TECHNICAL NOTE

Filing Code 1525 (P-401)

Bureau of Land Management U.S. DEPARTMENT OF THE INTERIOR

FORD TRUCKS

Figure 1

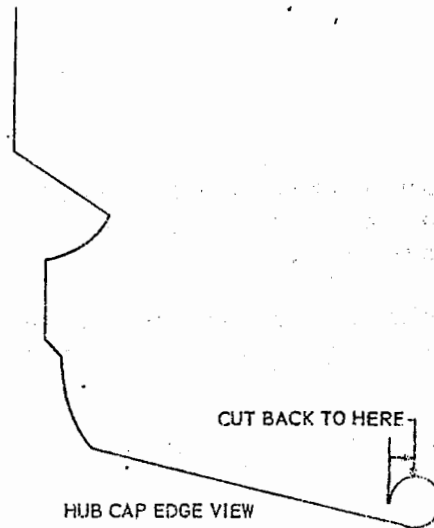
VI. Hub Cap Retention. (F&P250/350-1968-69)

To improve retention remove hub caps and grind the rolled inner edge of the cap at two opposite spots to match the two retaining bosses on the wheel. Remove metal from the inner rolled edge to a point approximately one-third of the total edge. Refer to Figure 1.

Figure 2

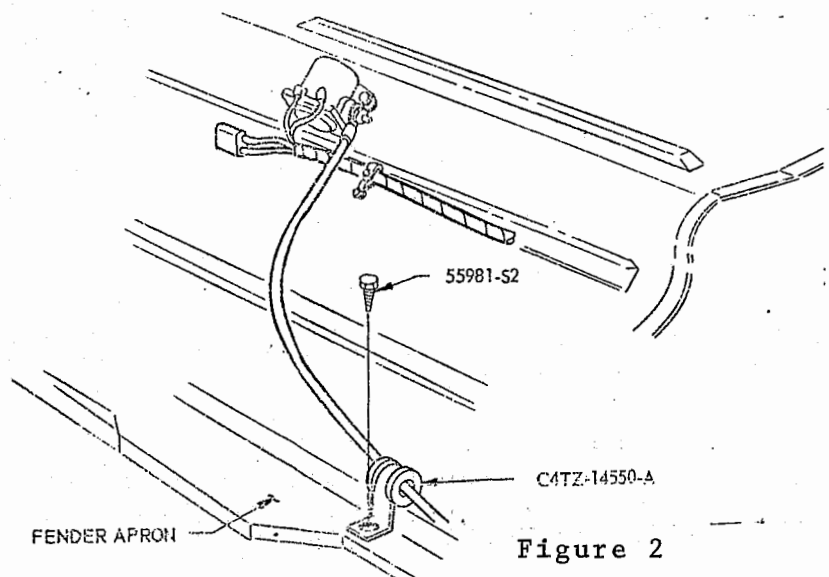
XIII. Grounded Starter Cable to Frame. (1968 - 69 F&B 500-750 Series Trucks)

To preclude the starter cable grounding on the frame, mount a new cable support, C4TZ-14550-A, to the right hand fender apron using a self tapping screw, Part No. 55981-S2 (1/4 inch - 14 x 1/2 inch). Refer to Figure 2.
